DATE: February 11, 2014
TO: Honorable Mayor and Members of the Village Council
FROM: John C. Gilbert, Village Manager
RE: Site Plan Review: 12-22-24 Crandon Boulevard and 51 Harbor Drive

DT: February 11, 2014
TO: John C. Gilbert, Village Manager
FR: Jud Kurlancheek, AICP, Director
Building, Zoning, and Planning Department
RE: Supplemental Site Plan Review Report and
Recommendation: 12-22-24 Crandon Boulevard and 51
Harbor Drive

DT: December 3, 2013
TO: John C. Gilbert, Village Manager
FR: Jud Kurlancheek, AICP, Director
Building, Zoning, and Planning Department
RE: Site Plan Review: 12-22-24 Crandon Boulevard
with access from 51 Harbor Drive

Exhibit 21

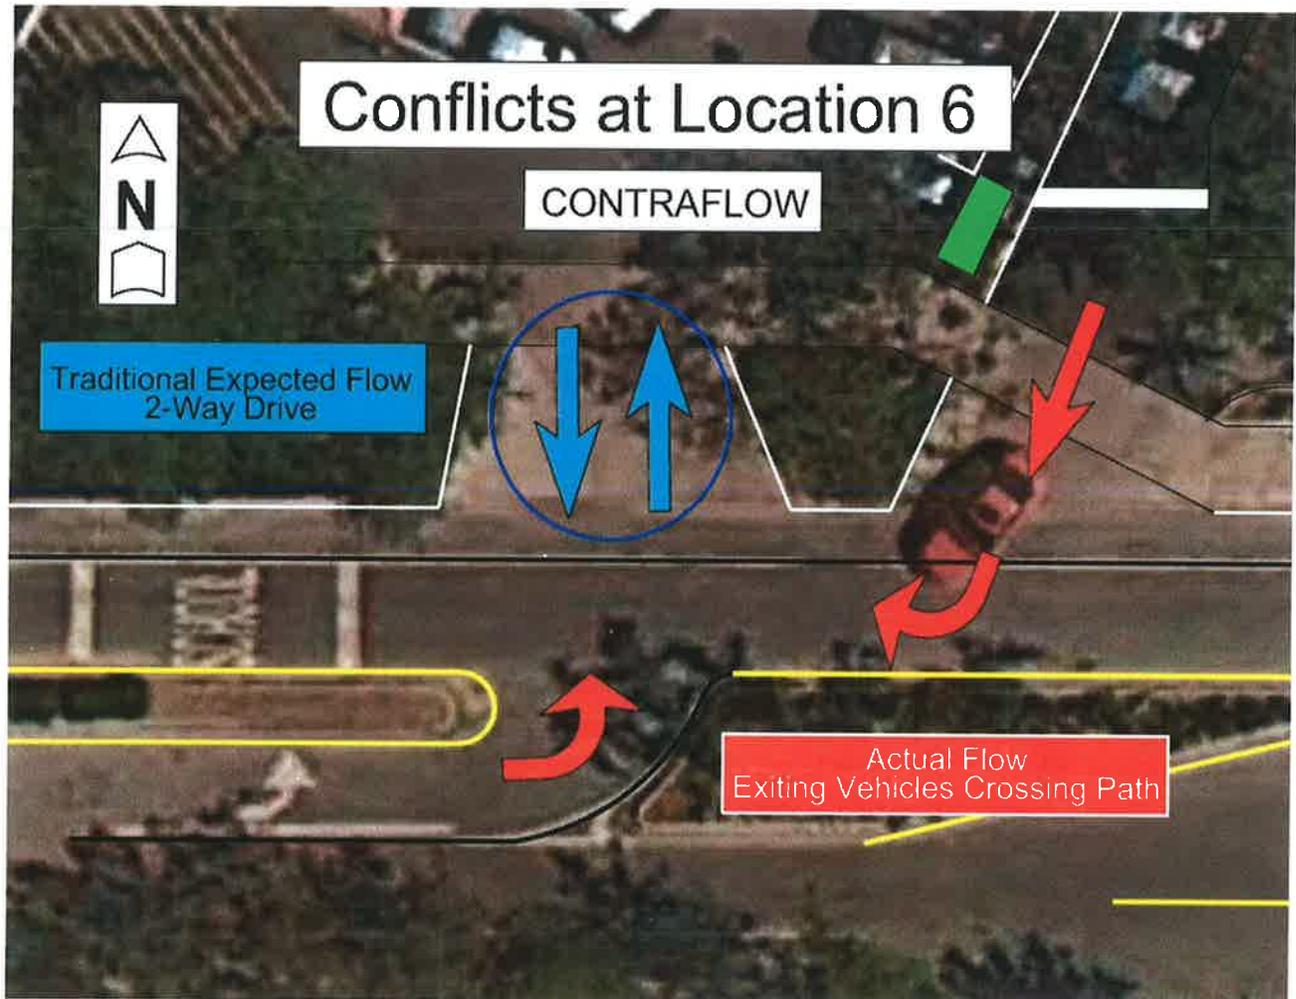
Location 6 is a traffic flow safety issue occurring at the Harbor Drive exit and entrances. Vehicles enter the facility via eastbound and westbound Harbor Drive have no notice that the entrance is one-way, therefore there is an expectation of vehicles entering and exiting from the same driveway. Additionally there is no notification of vehicles exiting the facility via the one-way exit east of the entrance. Finally, the vehicles exiting the facility cross paths with the vehicles entering the facility. This traffic flow pattern is contrary to the logical and expected situation when entering or exiting a driveway, in this case exiting west of the entrance. Due to the unexpected flow pattern, vehicles entering the facility will not be looking towards the exit ramp for potential hazards. **Exhibit 21** shows the flow safety issue at this location.

Exhibit 22

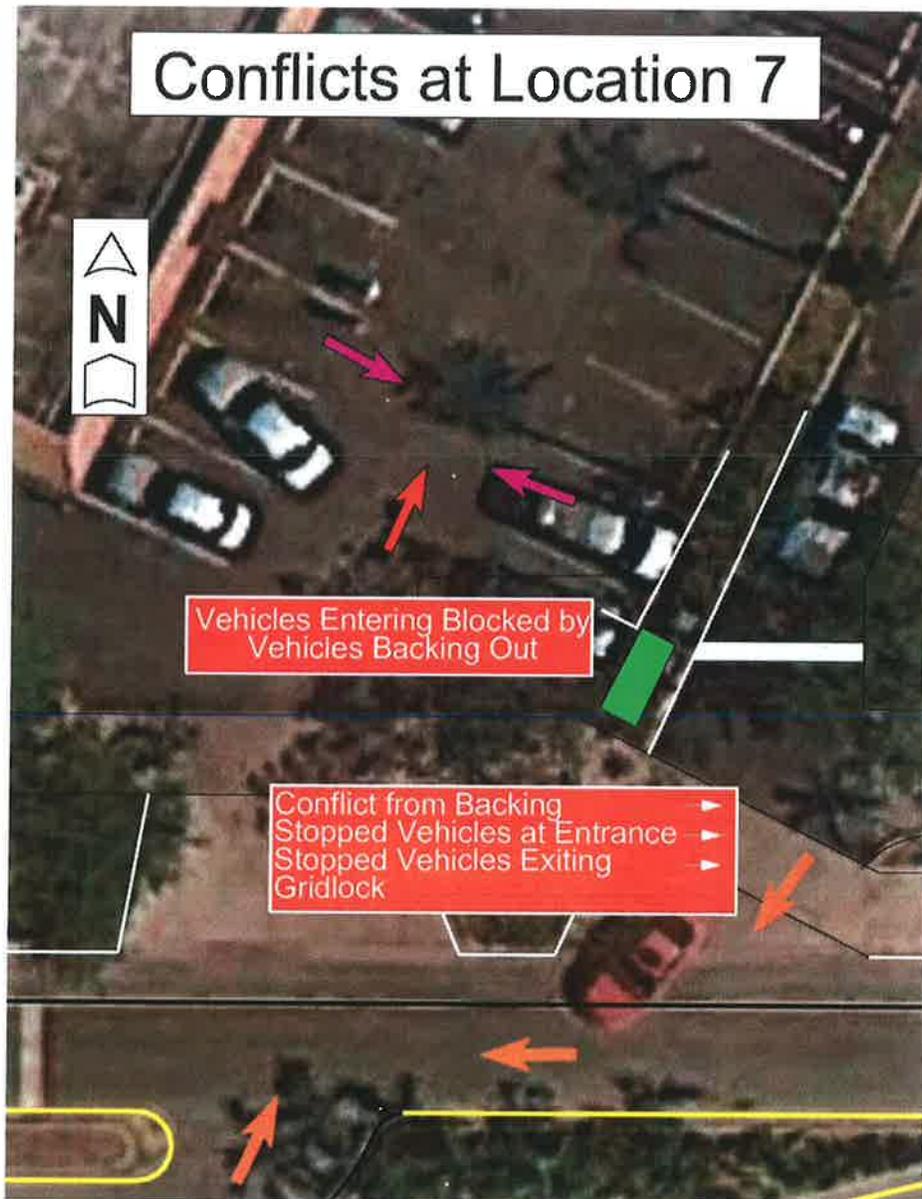
Location 7 is the parking lot within the facility entered via Harbor Drive that would access the proposed facility via the cross-access driveway. Parking spaces begin immediately north of the entrance driveway from Harbor Drive. Because of the narrow travel path along the parking lot all vehicles exiting their parking spaces must block thru traffic. This condition causes entering vehicles, whether turning right or left, to obstruct the westbound traffic lanes, potentially leading to collisions. Since the exit from the facility is obstructed as well from this, with enough traffic the exiting vehicles could possibly obstruct the cross-access driveway. **Exhibit 22** shows the issue at this location.
